Green Building/Energy Review Responses

Montgomery County
Department Of Permitting Services

Review Comments For:
Carpenter Shop Servant Quarters
2715 Cassidy Street
Silver Spring, MD 20910

A/P#: 725266+269 thru 272+274

A17

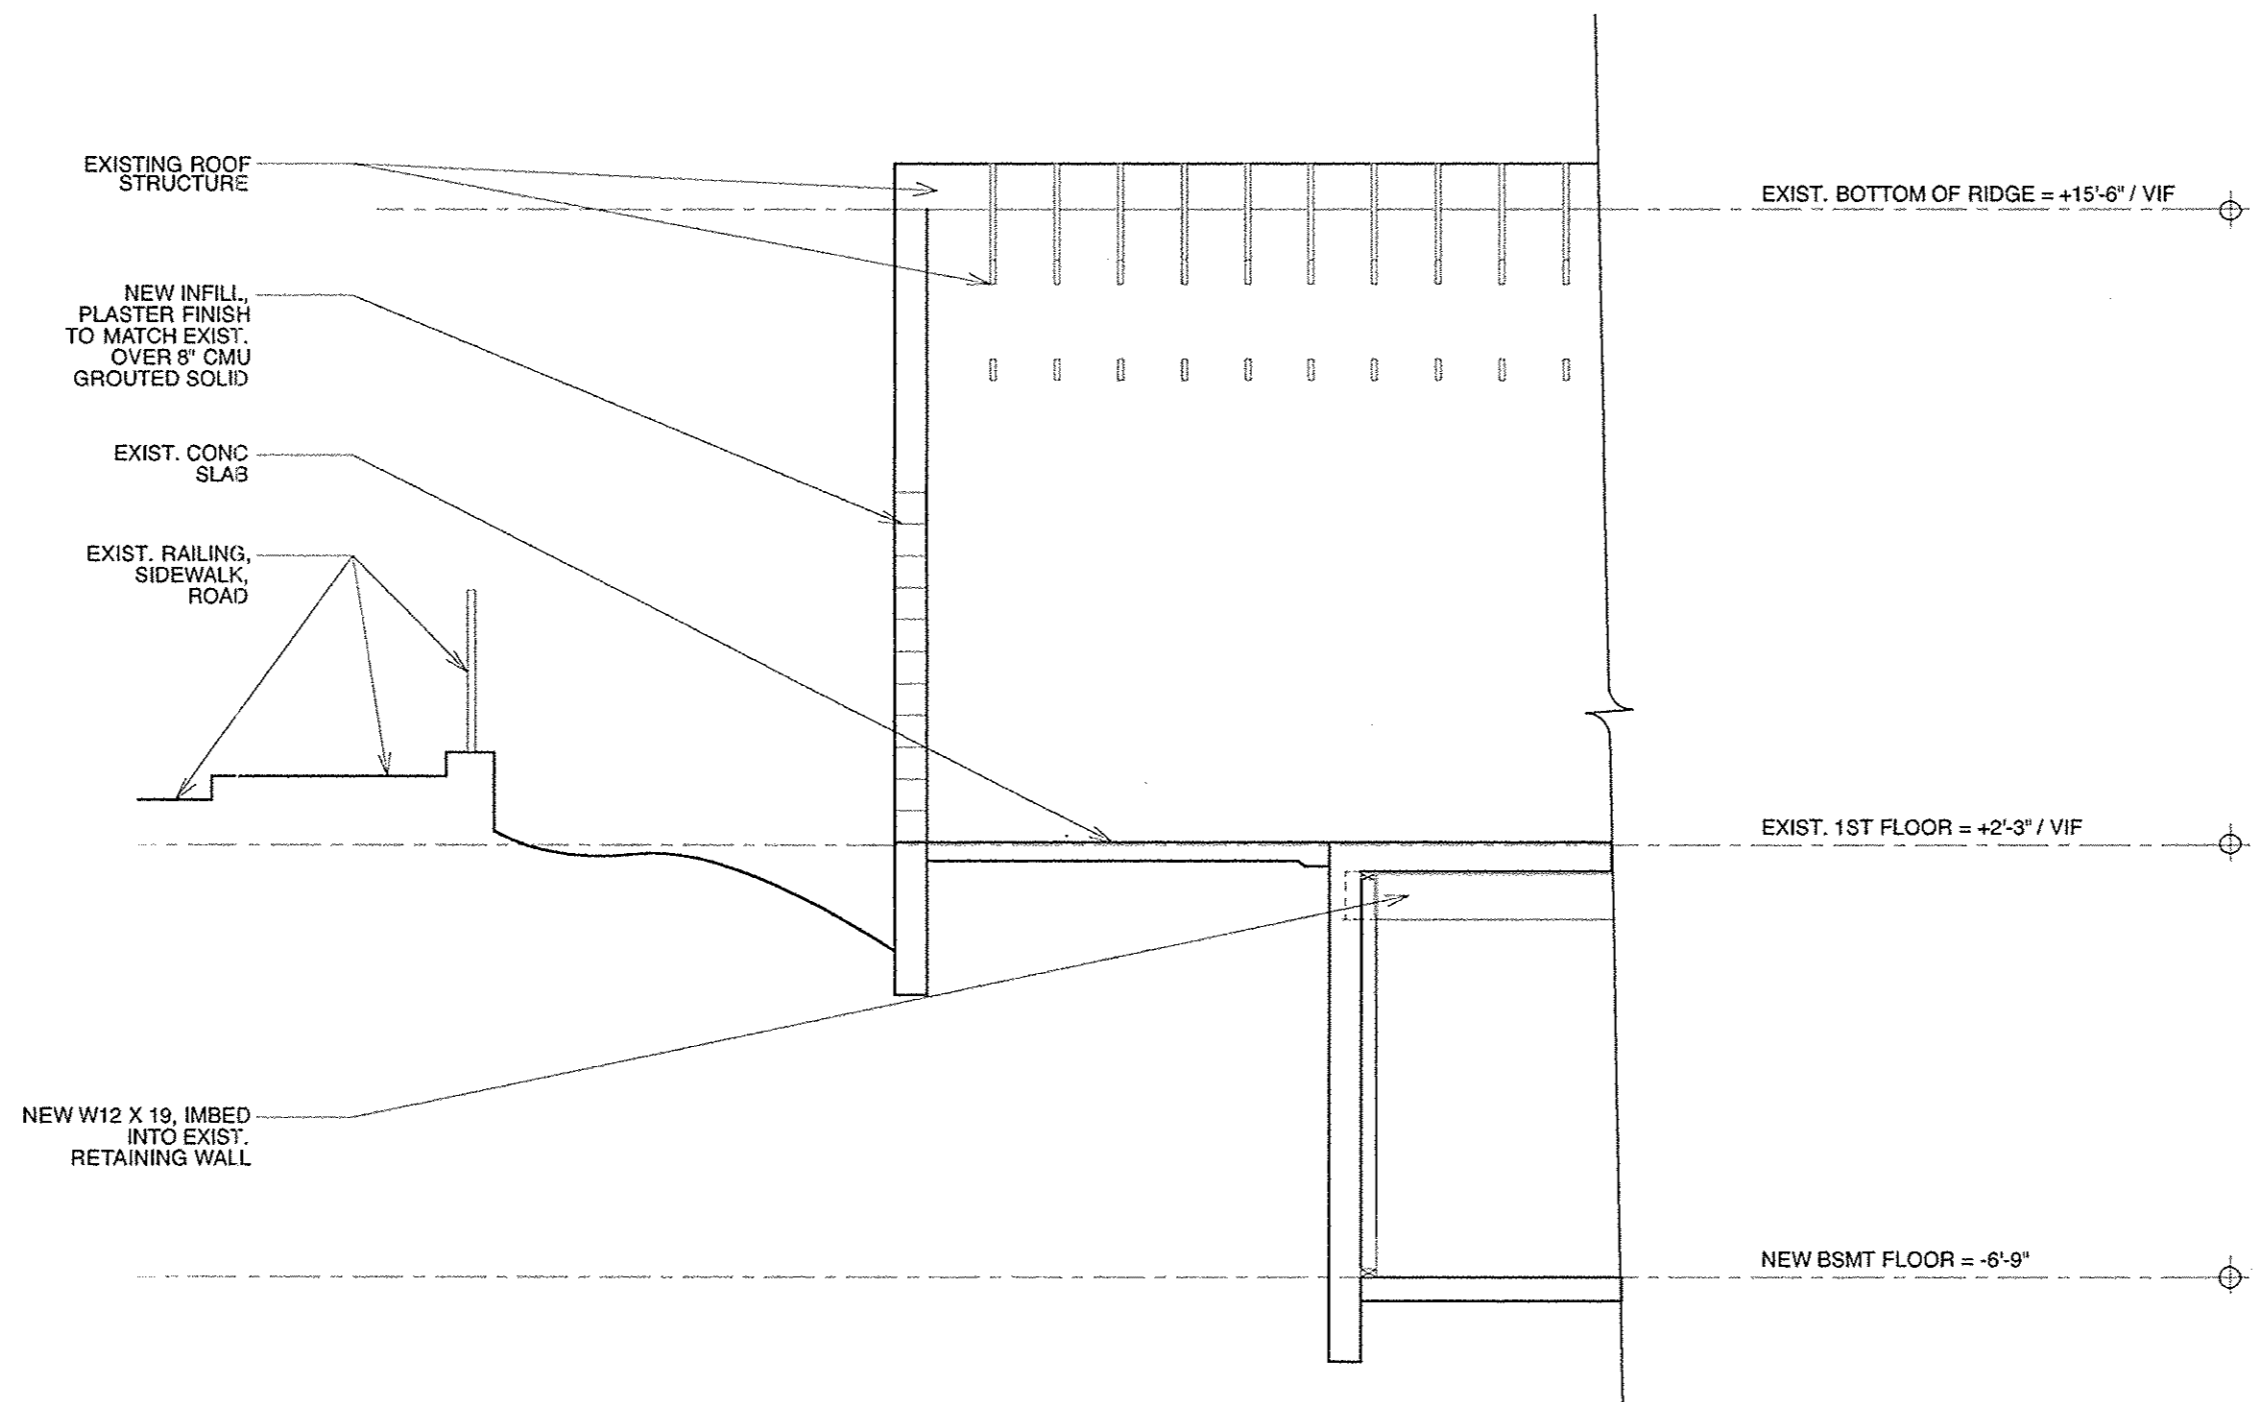
3. Provide air leakage specification per C402.5.

With that said, we have added, to sheets A15, A16, A17 and A18, the noted requirement to be verified in field related to the existing structure that can be accomplished that would otherwise not “threaten, degrade or destroy the historic form, fabric or function of the building”. Note that no alternations to the existing structure is occurring other than replacement of windows and repairing exterior roofing and brick masonry walls.

1
S6.1
NEW FOOTING DETAIL @ FOUNDATION WALL

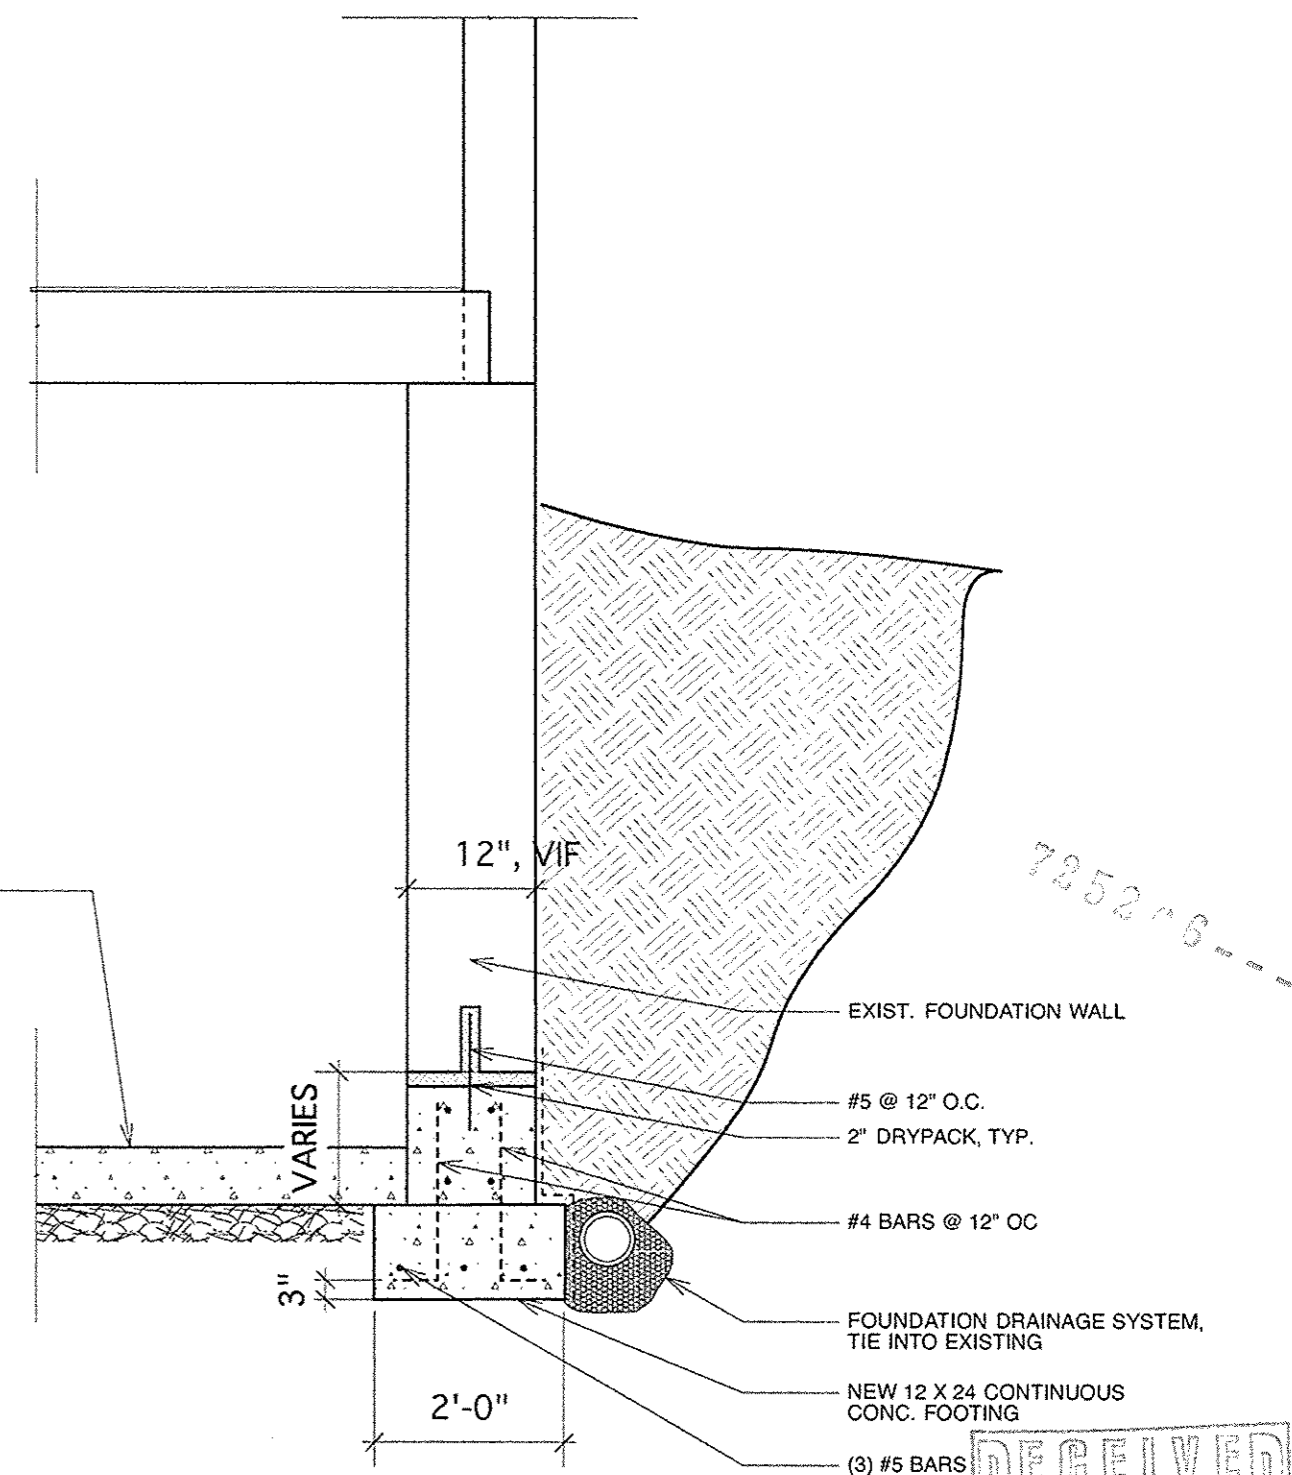
3. See previous comment, no details, no reinforcing are provided by structural engineer of record.

Previous comment; Provide slab on grade note and show all required details control/construction joints etc. Provide reinforcing for the new slab on grade.

B) On sheet S6, the Drawing 1/S6.1 is referenced and notes "REINFORCED CONCRETE SLAB OVER CONTINUOUS VAPOR BARRIER SEALED AT SLAB PERIMETER AND SLAB WITH 6 X 6 X W20 WITH PENETRATIONS ON ALL CONTINUOUS RIGID INSULATION OVER COMPACTED GROUND FILL OR EQUAL. SEE STRUCTURAL DRAWINGS FOR MORE INFORMATION".

3 NEW FRAMING TO EXIST. EXTERIOR MASONRY WALL
S7.1 SCALE: 1-1/2" = 1'-0"

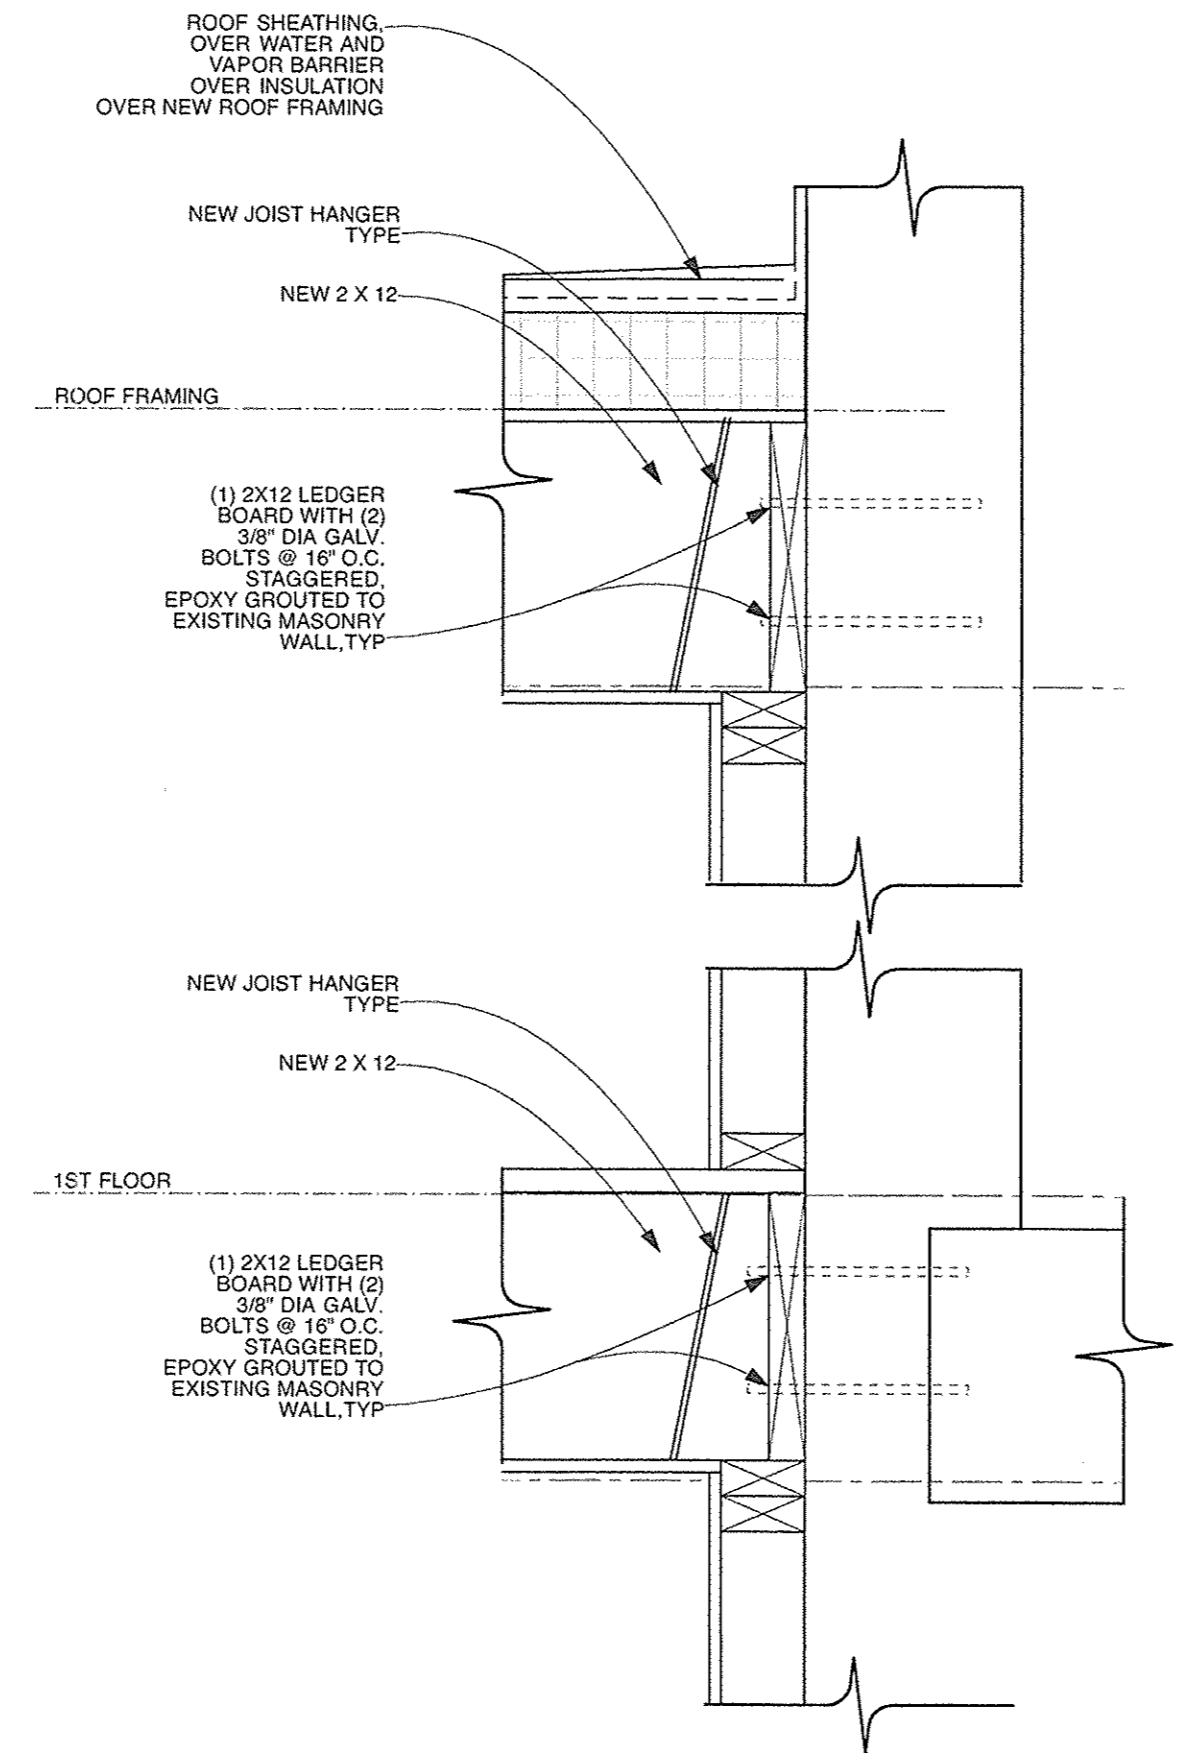
- 18. No section is provided.** Drawing S9; provide section between building A and B show connections between new 2x12's to wall or LVL.

RESPONSE #18: On Sheet S9, a section marker referencing 3/s7.1 shows the new 2x12's connection at 1st floor and roof by: "(2) 2 x 12 LEDGER BOARD WITH (2) 3/8" DIA GALV BOLTS AT 16" O.C. STAGGERED, EPOXY GROUTED TO EXISTING MASONRY WALL"
